WMA- Gene Howe, Canadian TX, ADA Evaluation

Accessibility Evaluation

Inspection Date: 06/27/2022

Report Date: 01/21/2024

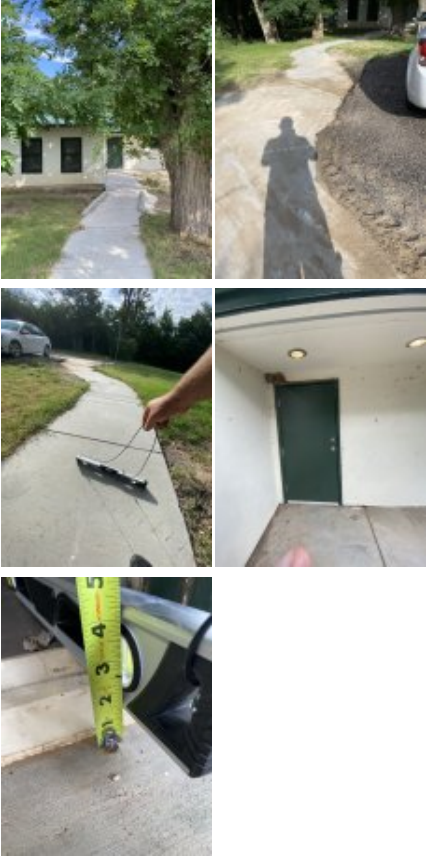
Finding Number	Area Description	Finding	As Built	Recommendation	Citation	Photos	Figure
1	Exterior of Property (Public): Bunk House/HQ Parking (1 Spot) 1 Van - Van Accessible Stall	The striping and markings for the accessible parking stall, loading/unloading access aisle are dilapidated and in need of repair and/or maintenance.	Parking stall outside of HQ building. Stall borders and ISA insignia is faded or missing,	https://www.access-board.gov/ada/#ada-502_2 https://www.access-board.gov/ada/#ada-502_3_3	2012 TAS Section: 502.3.3 2010 ADAS Section: 502.3.3 2015 ABAAS Section: 502.3.3, 503.3.3		
2	Exterior of Property (Public): Bunk House/HQ Parking (1 Spot) 1 Van - Access Aisle (Van)	The access aisle is in not nearly compliant. The access ai the minimum width. The access aisle is not as long as the parking space it serves. There are no markings to discourage parking. The floor or ground surface is not firm stable or slip resistant. The parking space contains changes in level and/or gaps that exceed the maximum allowable requirements.	Access aisle has multiple infractions. Access aisle slope is over 2% due to gravel pile up, area is not clearly marked. Access aisle fails to run the length of parking spot Obstructions, changes in elevation, abrupt edges, and curb ramps are prohibited from being placed in access aisle. Floor or Ground Surfaces. Access aisles are required to be nearly level in all directions to provide a surface for wheelchair transfer to and from vehicles. Access aisle width requirments depend on van stall size. van stall 11' access aisle 5' or van stall 8' access aisle 8'	https://www.access-board.gov/ada/#ada-502_3	2012 TAS Section: 502.3 2010 ADAS Section: 502.3 2015 ABAAS Section: 502.3
